**UNITED STATES ENVIRONMENTAL PROTECTION AGENCY  
ONE CONGRESS STREET, SUITE 1100  
BOSTON, MA 02114-2023**

Re: EPA Conditional Approval of General Electric's May 25, 2007 submittal titled "Conceptual Removal Design/Removal Action Work Plan for Soils Adjacent to Silver Lake"  
GE-Pittsfield/Housatonic River Site, Pittsfield, MA

## Attachment

**Figure 1** – General depiction of outfall locations not identified or incorrectly labeled by GE on Figure 1-2, Silver Lake Site Plan and Existing Conditions, and Table 3-1 in the Conceptual RD/RA. Not to scale and locations are approximate. Photo numbers correspond to photos listed below.

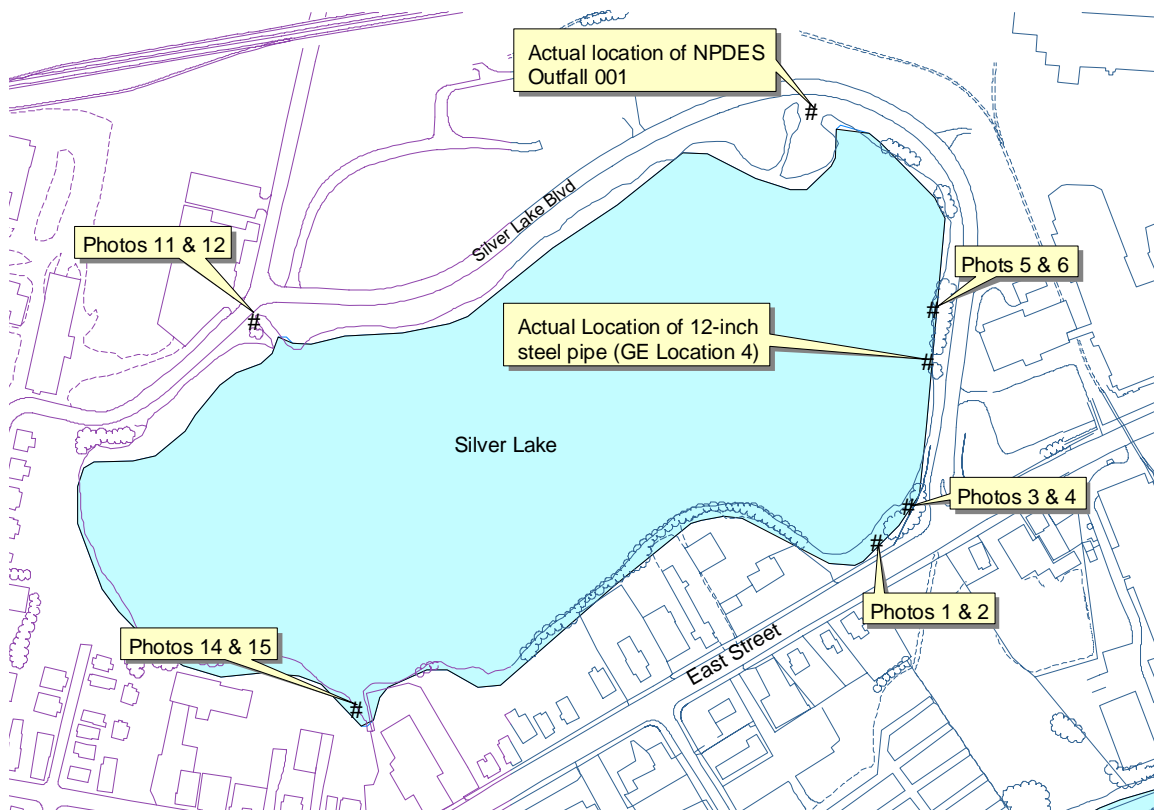
**Photo 1 - GE Location 2** - Close-up view of a partially silted-in outfall pipe in the general vicinity of the “4-inch water blowoff” identified by Hill Engineers during September 2006 survey activities, but which GE was unable to locate during its 2008 survey. This location was omitted from Table 3-1 (Outfalls Identified Around Silver Lake) and Figure 1-2 (Silver Lake Site Plan and Existing Conditions) of GE’s July 2008 *Conceptual Removal Design/Removal Action Work Plan for Silver Lake Sediments* (Conceptual Work Plan) because the pipe could not be located by GE in the field.

**Photo 2 - GE Location 2** - View of the location of the partially silted-in outfall pipe in the vicinity of the “4-inch water blowoff” identified by Hill Engineers in 2006.

**Photo 3** - Close-up view of a subsurface outfall pipe not identified by GE near the southeast corner of Sliver Lake (Recreational Area 5). This pipe is located between GE Location 2 (which was omitted from Conceptual Work Plan Table 3-1 and Figure 1-2) and GE Location 3, being approximately 30 feet south of the foundation of a former high-tension power line tower in this area.

**Photo 4** - View of the location of the subsurface outfall pipe identified by EPA between GE Locations 2 and 3.

**Photo 5 - GE Location 4** - Close-up view of a 20-inch steel outfall pipe at the location EPA believes to be GE NPDES Outfall 004. This location appears to be mapped correctly on GE Figure 1-2, except that GE identifies it as a 12-inch steel pipe. EPA notes that there is a 12-inch steel pipe approximately 30 feet south of this location that is not presented on Figure 1-2 or Table 3-1. GE appears to be confusing the 20-inch pipe shown above with the 12-inch steel pipe.

**Photo 6 - GE Location 4** - View of the location of the 20-inch outfall pipe believed by EPA to be GE NPDES Outfall 004.

**Photo 7 - GE Location 14** - View of a submerged pipe believed by EPA to be GE NPDES Outfall 001. Figure 1-2 places this outfall pipe within approximately 20 feet of the concrete structure at GE Location 13. EPA notes that this outfall is actually located approximately 115 feet northwest of the structure at GE Location 13.

**Photo 8 - GE Location 17** - View of the location of one of two outfall pipes at GE Location 17, which were identified by Hill Engineers in September 2006, but which GE referred to as “indications of a pipe” on Figure 1-2 and Table 3-1. There is a subsurface steel pipe at this location.

**Photo 9 - GE Location 17** - Close-up view of the subsurface steel pipe at GE Location 17 referred to on Table 3-1 and Figure 1-2 as “indications of a pipe”.

**Photo 10 - GE Location 17** - View of the second of two outfall pipes at GE Location 17. This partially silted-in pipe, which is not referenced in Figure 1-2 or Table 3-1, appears to be associated with an adjacent pair of catch basins along Silver Lake Boulevard.

**Photo 11** - Close-up view of a steel outfall pipe not identified by GE located between GE Locations 19 and 20 (immediately east of the 42-inch concrete spillway at GE Location 20). This outfall pipe appears to be associated with an adjacent pair of catch basins at the junction of Silver Lake Boulevard and Fourth Street.

**Photo 12** - View of the location of the steel outfall pipe identified by EPA between GE Locations 19 and 20 that is apparently associated with catch basins at the junction of Silver Lake Boulevard and Fourth Street.

**Photo 13 - GE Location 22** - View of a sand delta associated with the subsurface outfall pipe at GE Location 22. The amount of material in this deposit suggests that the outfall pipe at this location continues to experience heavy flow volume.

**Photo 14** - Close-up view of a clay pipe which was not identified by GE, located between GE Locations 22 and 1, at Parcel I9-9-19.

**Photo 15** - View of the location of the clay pipe between GE Locations 22 and 1, at Parcel I9-9-19.
